Safety Evaluation Report

related to the final design approval
of the GESSAR II
BWR/6 Nuclear Island Design

Docket No. 50-447

NUREG-0979
Supplement No. 4

Figure 15.2 GESSAR II UPPS
Source: NEDE-30640

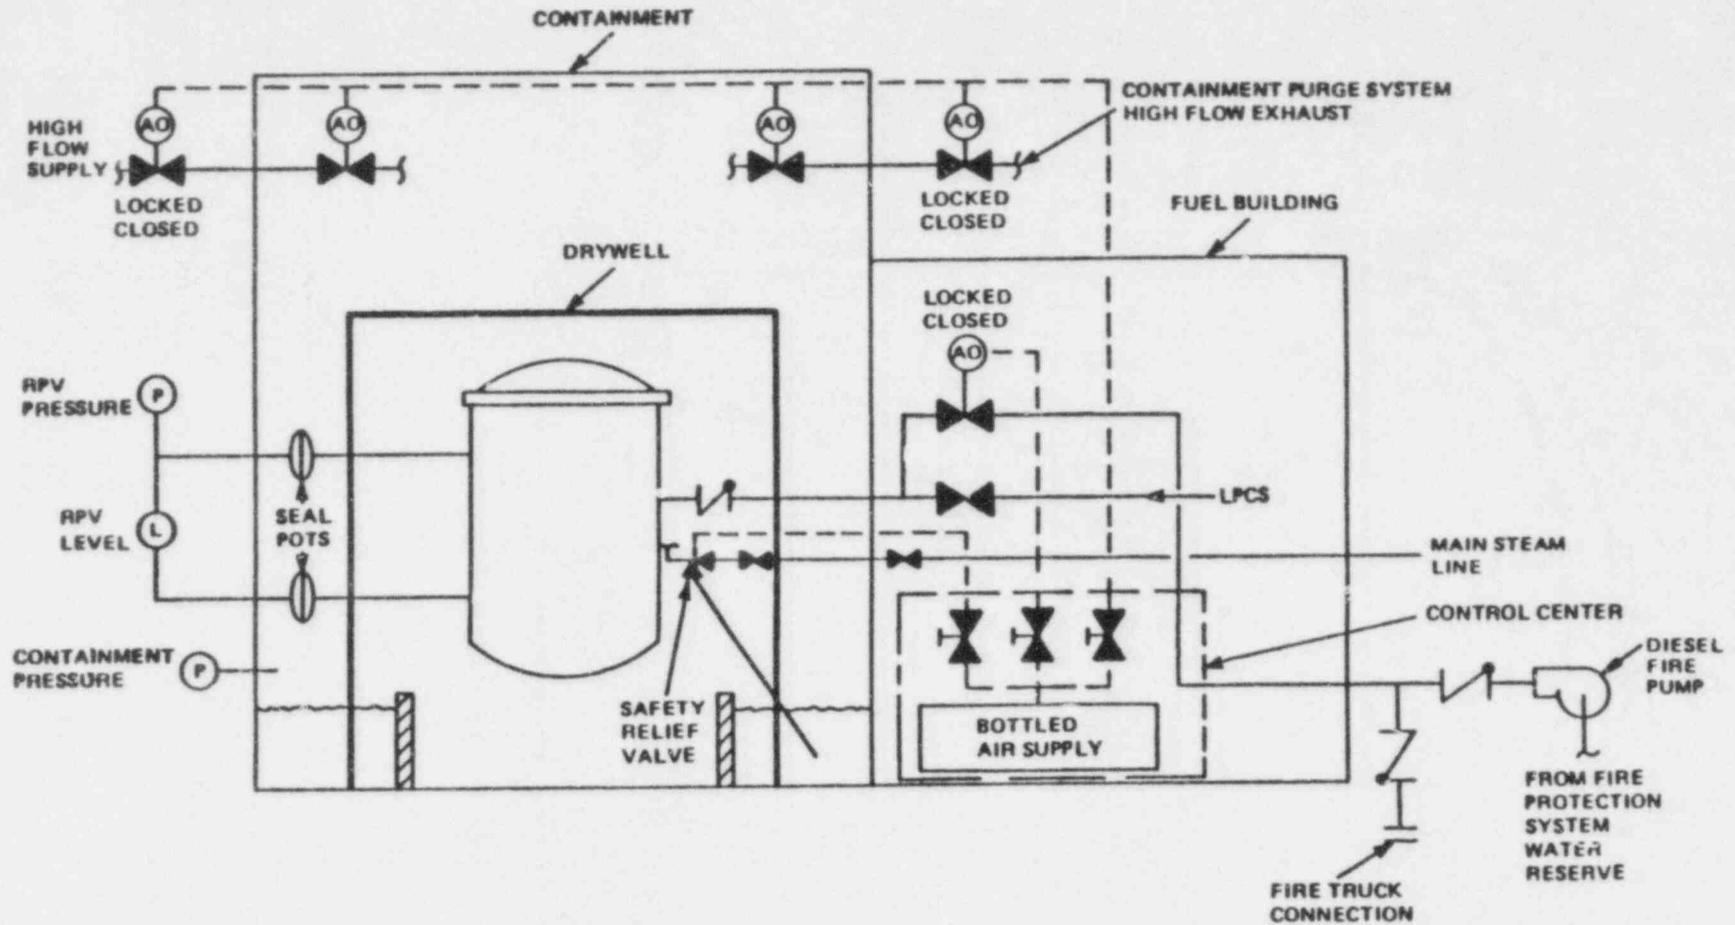
GE will provide detailed design information when an individual applicant references the GESSAR II design. Figure 15.2 shows a preliminary conceptual design of UPPS. The three primary functions of the UPPS are to (1) provide a reactor pressure vessel (RPV) makeup water supply capable of keeping the core covered, (2) provide RPV depressurization, and (3) provide containment heat removal. The system utilizes portions of the plant's emergency fire system, with modifications to allow for injection of water into the low-pressure core spray line. Dedicated air bottles will be used to provide motive power for air-operated injection valves, as well as operation of the safety/relief valves that must be used to depressurize the plant before injection from the low-pressure fire pumps. Air-operated containment vent valves will also be included to permit

After evaluating the potential design modifications, GE incorporated UPPS into the GESSAR II design. However, because of the preliminary nature of the design, the staff could not arrive at definitive assessments of the system's performance and capabilities. Conceptually the system offers significant advantages for responding to station blackout events, a class of accidents shown by the PRA to be a dominant contributor to core-melt frequency.

Although the UPPS system as proposed by GE has no seismic qualifications, the staff's PRA review indicated that seismic events dominate public risk. Without design details of the UPPS system, it was not possible to perform a detailed assessment of the system's seismic capabilities and response. However, the staff's contractor, BNL, in a draft report, "An Evaluation of Core Damage Reduction Benefits of Ultimate Plant Protection System" (Shiu and Reed, 1985), estimates the likely present seismic capability of the proposed UPPS. BNL modeled the core-melt reduction impact for upgrading the seismic capacity

From a defense-in-depth viewpoint, the staff also sees benefits to a seismically hardened UPPS even if the cost-benefit ratio is not shown to be attractive. The UPPS was proposed to be a final line of defense for the GESSAR II design. Very little plant equipment is required with this system to provide extended core cooling and containment heat removal. The staff evaluation of the GESSAR II PRA has shown that seismic core-melt risk exceeds the core-melt risk from internal events. Therefore, the proposed fall-back function of UPPS should show capabilities to respond to this class of event. However, the staff does affirm GE's design goal to maintain UPPS as a simple, manually initiated system of last resort.

- seismic upgrade to UPPS
- dedicated power supply to hydrogen ignitor system
- 10-hour station batteries
- ability to power a dc battery charger from ignitor power supply

The staff requires that GE provide details of how the modifications discussed in this section will be incorporated in the GESSAR II design. The staff requirements for these design improvements are conceptual in nature. In presenting the required detailed information on these systems, alternative designs may be proposed that offer equivalent functional performance. The staff requires that this information be submitted in sufficient time to complete its evaluation before issuing a construction permit or an operating license for a facility referencing the GESSAR II design. At this time, the staff does not believe that any design modifications in addition to those discussed and required above are warranted.
